ECE/TRANS/WP.11/2009/19
7 September 2009

ATP HANDBOOK

Proposed addition to Annex 1, Appendix 2 of the ATP Handbook with layouts for the placement of temperature measuring devices inside and outside of transport equipment – tanks with one, three and more compartments during tests aimed at determining the overall coefficient of heat transfer (K coefficient)*

Transmitted by the Government of the Russian Federation

Fig. 1

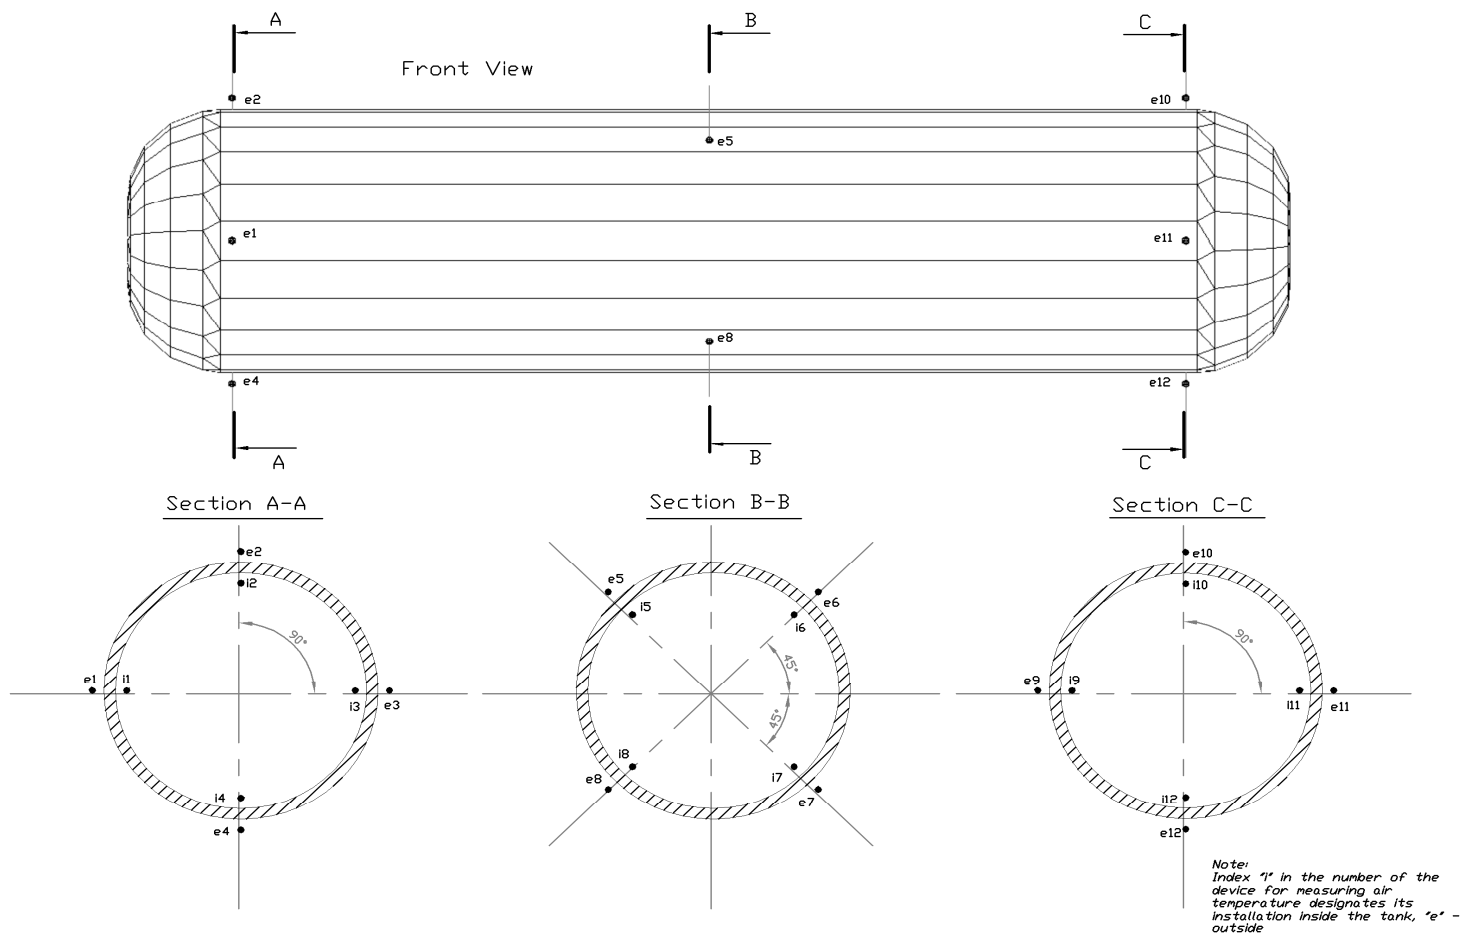
Comment to subparagraph (a) of Annex 1, Appendix 2, paragraph 21:

The layout of the placement of air temperature measuring devices inside and outside tanks with one compartment is shown in figure 1;

Fig. 2.

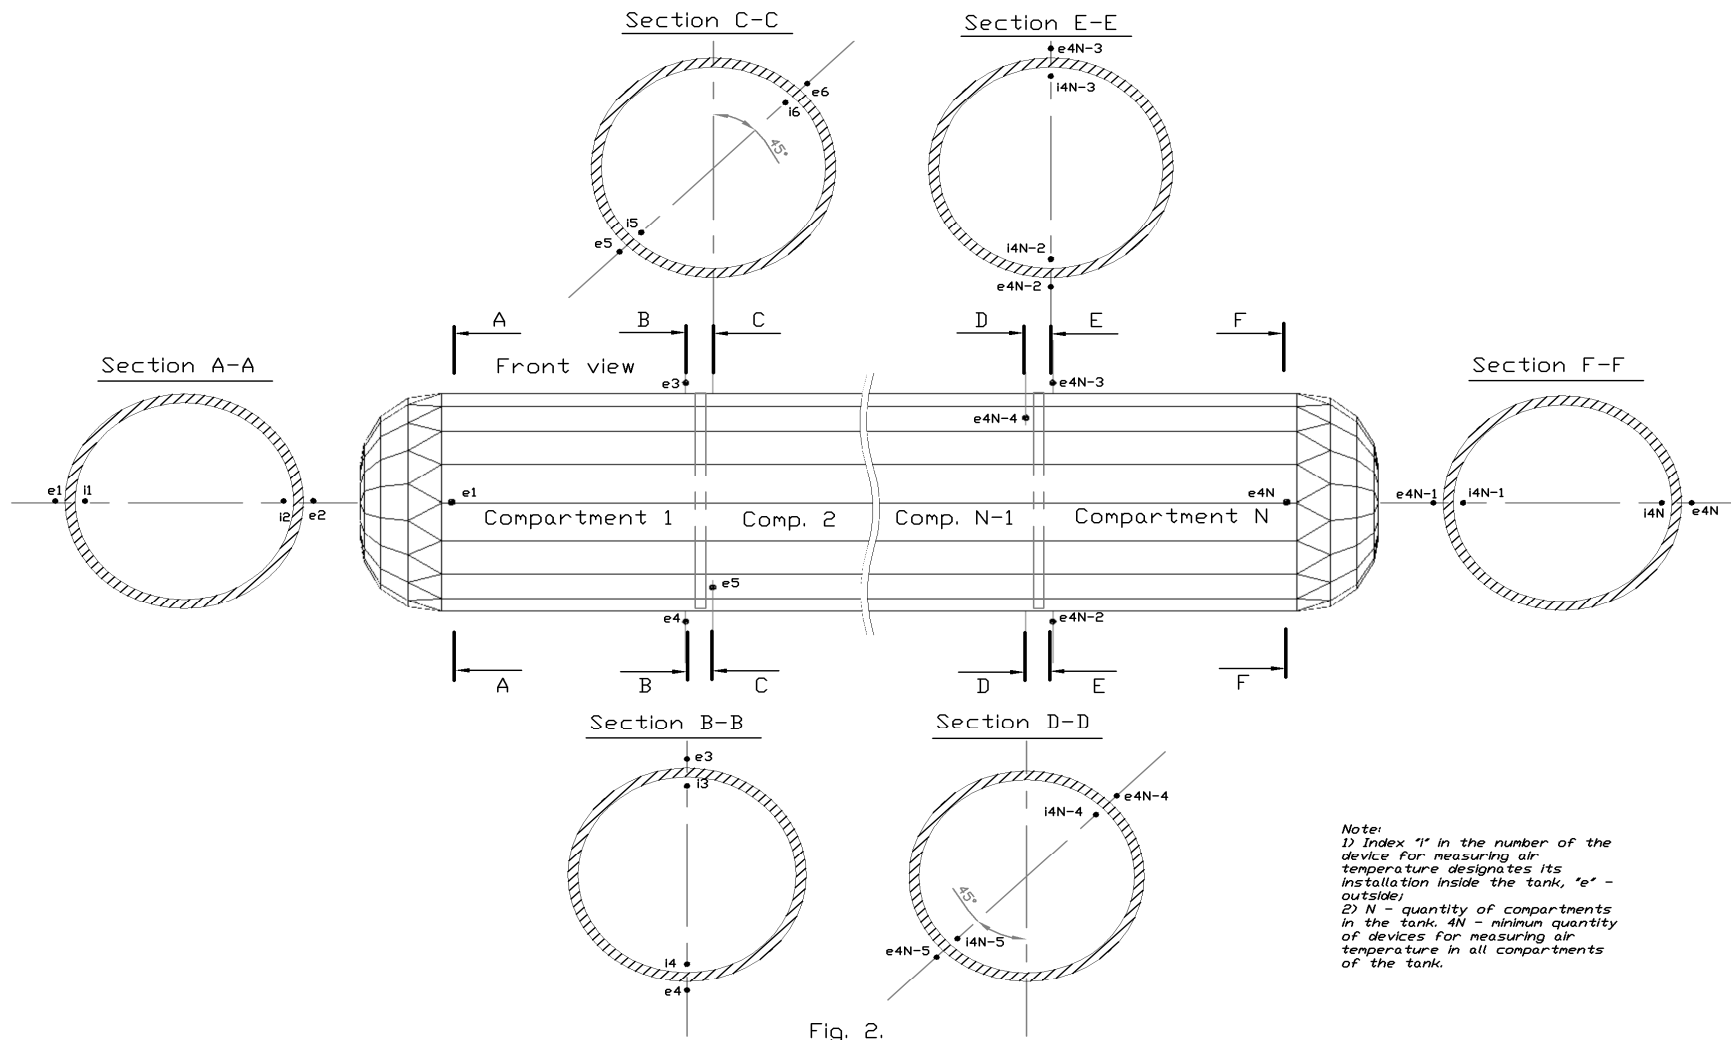
Comment to subparagraph (b) of Annex 1, Appendix 2, paragraph 21:

The layout of the placement of air temperature measuring devices inside and outside tanks with three or more compartments is shown in figure 2.

Note:
 1) Index 'i' in the number of the device for measuring air temperature designates its installation inside the tank, 'e' - outside;
 2) N - quantity of compartments in the tank, 4N - minimum quantity of devices for measuring air temperature in all compartments of the tank.
